STATE HIGHWAY 105 / JACKSON CREEK PKWY. - PHASE 2 CONSTRUCTION PLANS			
ROADWAY IMPROVEMENT PLANS			
STANDARD NOTES			
DESIGNED BY	PRA	SCALE	DATE 02-23-23
DRAWN BY	PRA	(H) 1"=VARIES	SHEET 2 OF 23
CHECKED BY	(V) 1"= N/A	JOB NO.	1.302.22

STATE HIGHWAY 105 / JACKSON CREEK PKWY. - PHASE 2 CONSTRUCTION PLANS			
ROADWAY IMPROVEMENT PLANS			
DEMOLITION PLAN			
DESIGNED BY	PRA	SCALE	DATE 02-23-23
DRAWN BY	PRA	(H) 1" = 60'	SHEET 4 OF 23
CHECKED BY	(V) 1" = N/A	JOB NO.	1302.22

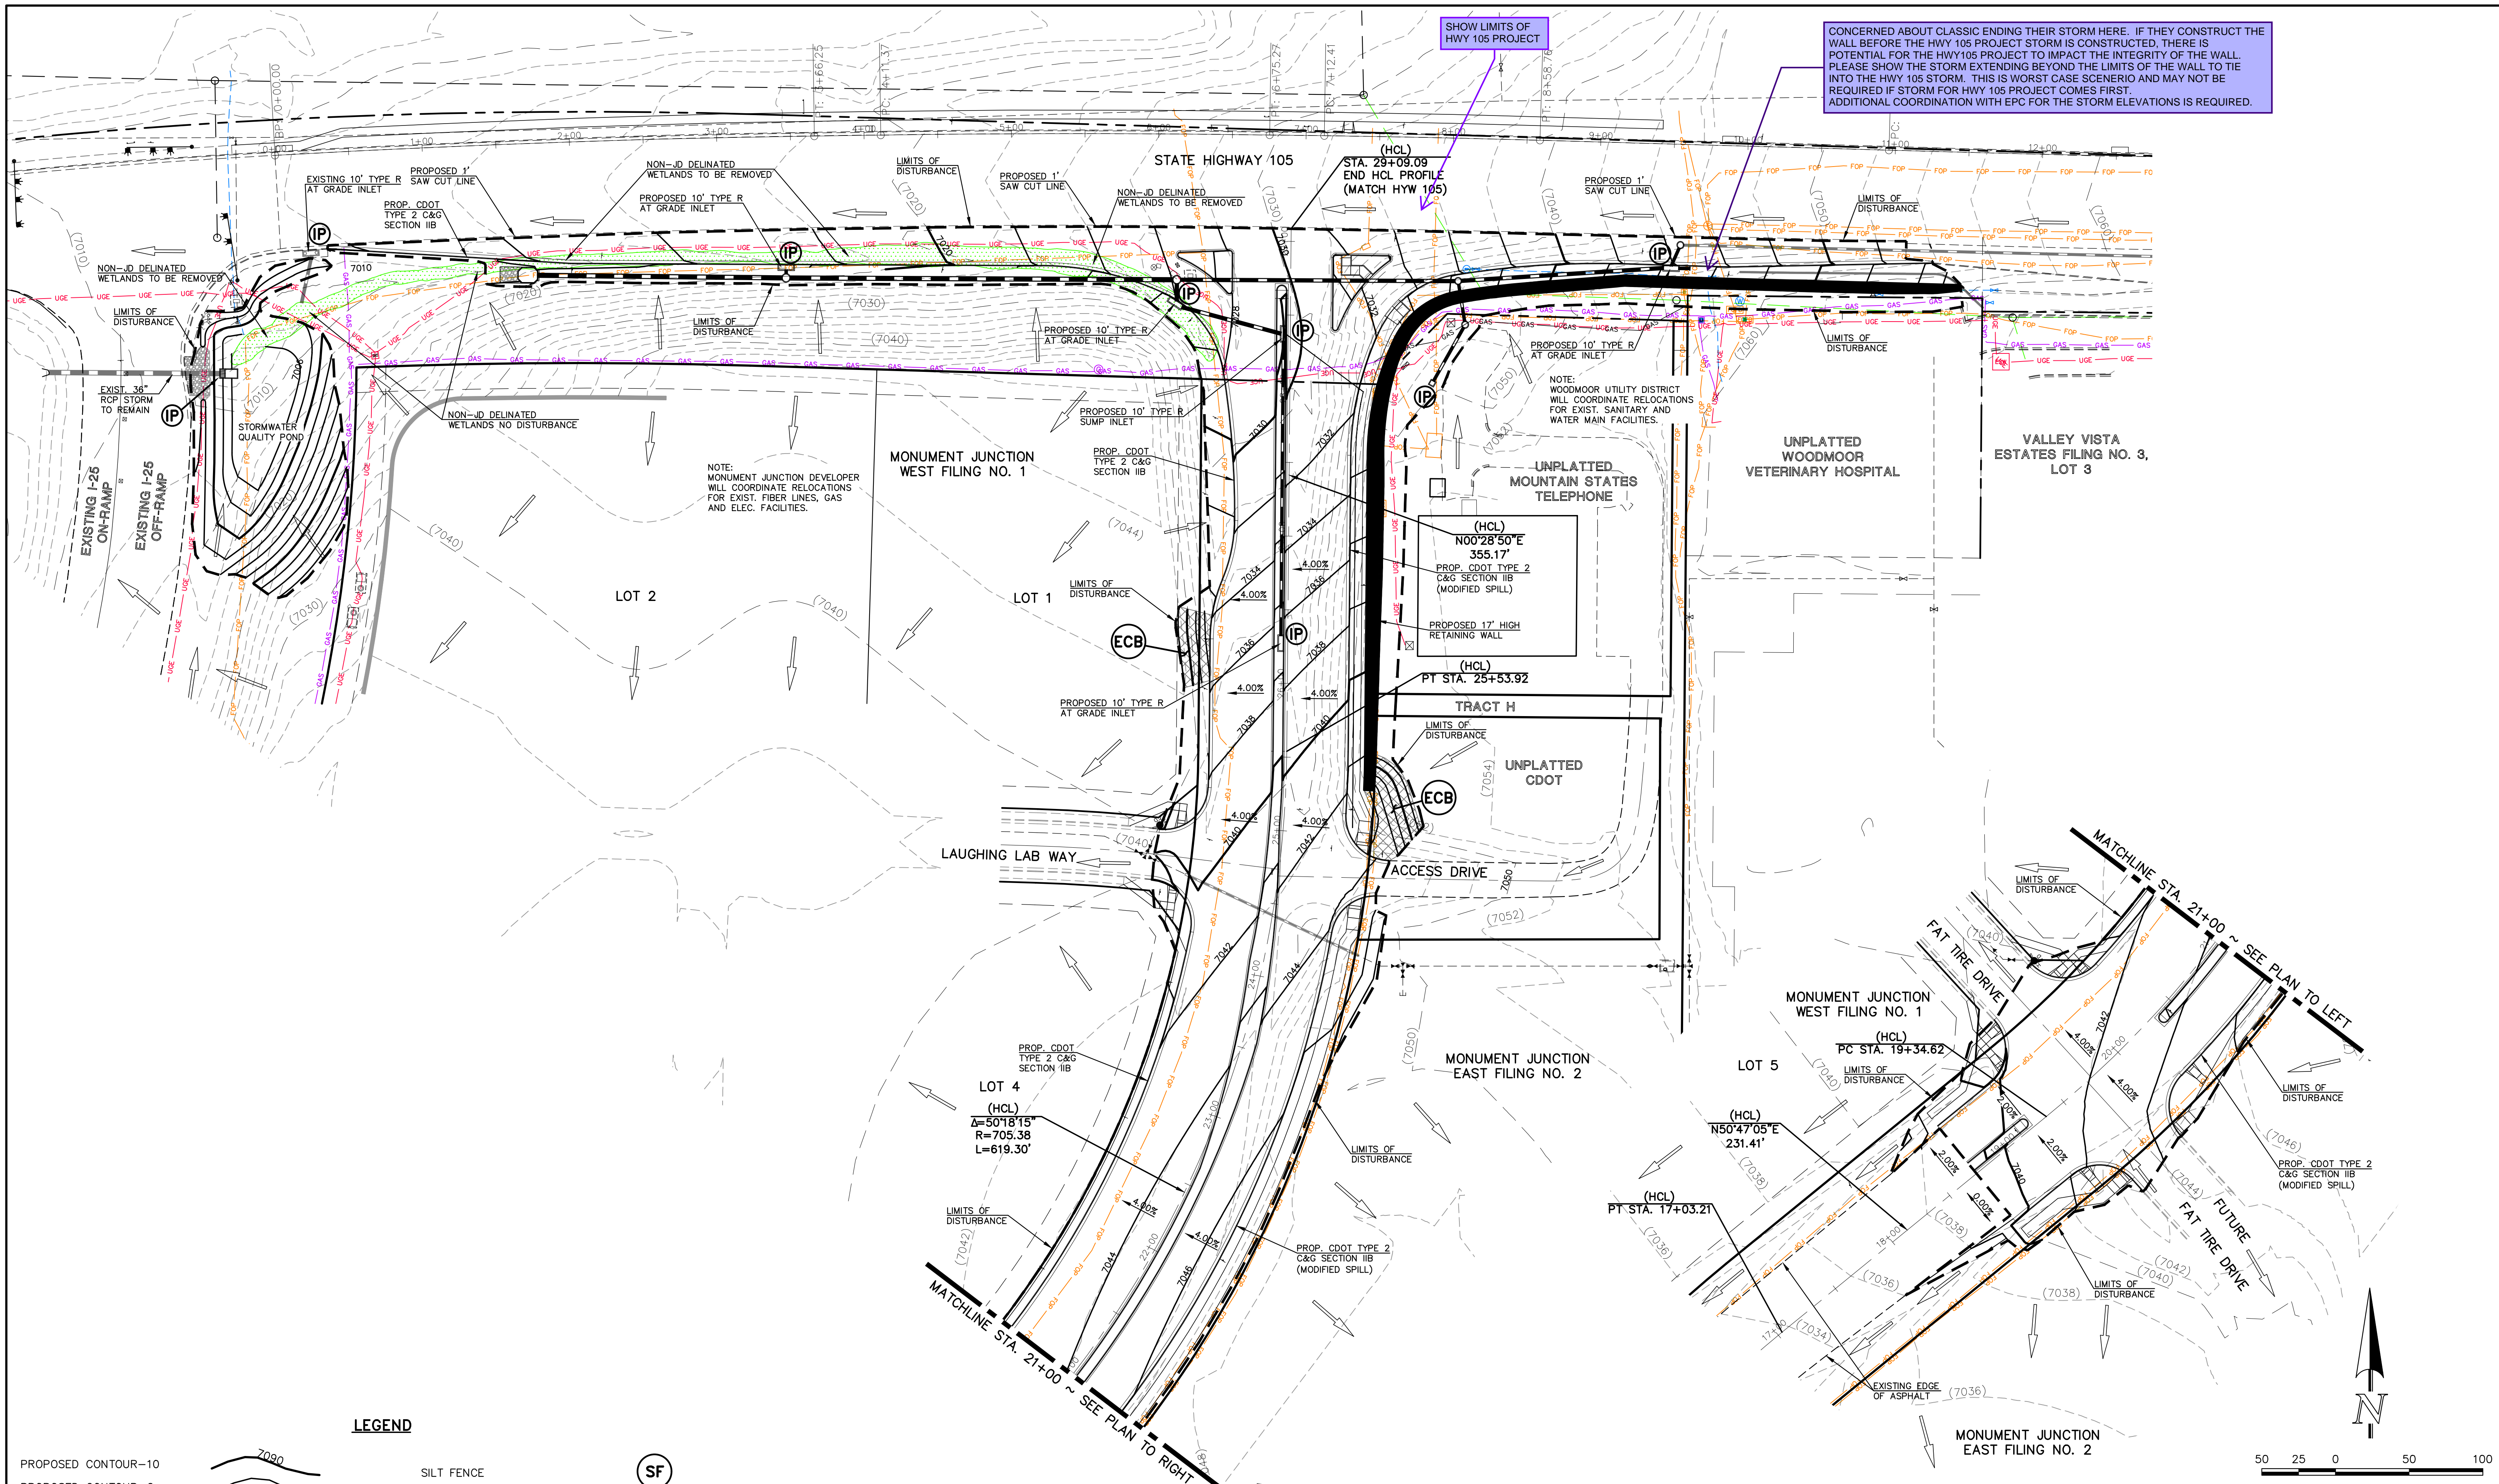
CONCERNED ABOUT CLASSIC ENDING THEIR STORM HERE. IF THEY CONSTRUCT THE WALL BEFORE THE HWY 105 PROJECT STORM IS CONSTRUCTED, THERE IS POTENTIAL FOR THE HWY105 PROJECT TO IMPACT THE INTEGRITY OF THE WALL. PLEASE SHOW THE STORM EXTENDING BEYOND THE LIMITS OF THE WALL TO TIE INTO THE HWY 105 STORM. THIS IS WORST CASE SCENARIO AND MAY NOT BE REQUIRED IF STORM FOR HWY 105 PROJECT COMES FIRST. ADDITIONAL COORDINATION WITH EPC FOR THE STORM ELEVATIONS IS REQUIRED.

SHOW LIMITS OF HWY 105 PROJECT

**CONCEPTUAL PLAN VIEW**  
N.T.S.

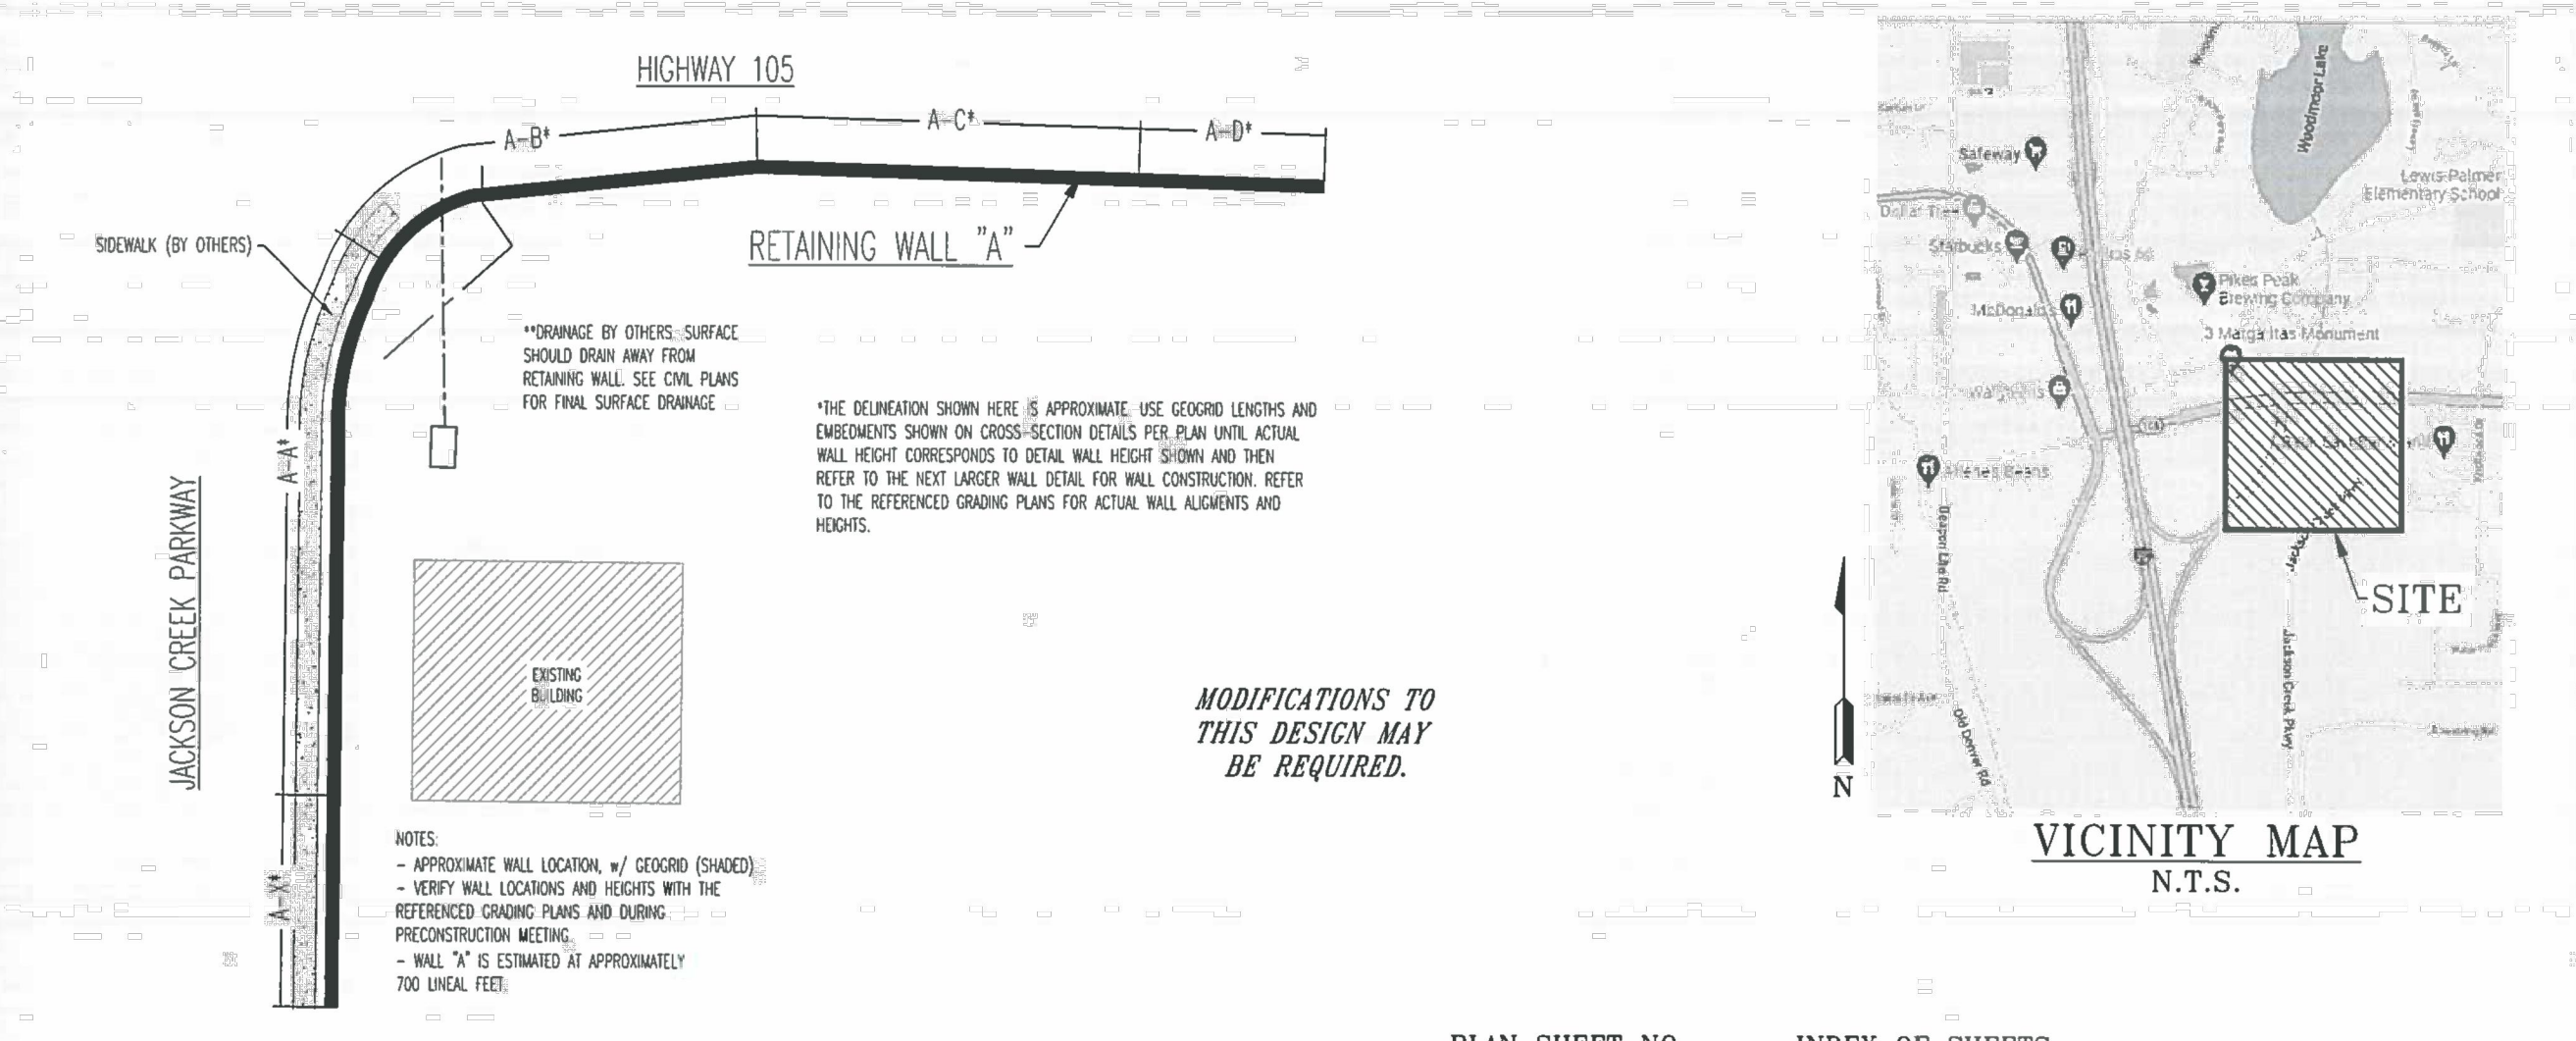
Include calculation in drainage report to show that swales is sized to adequately handle flow.
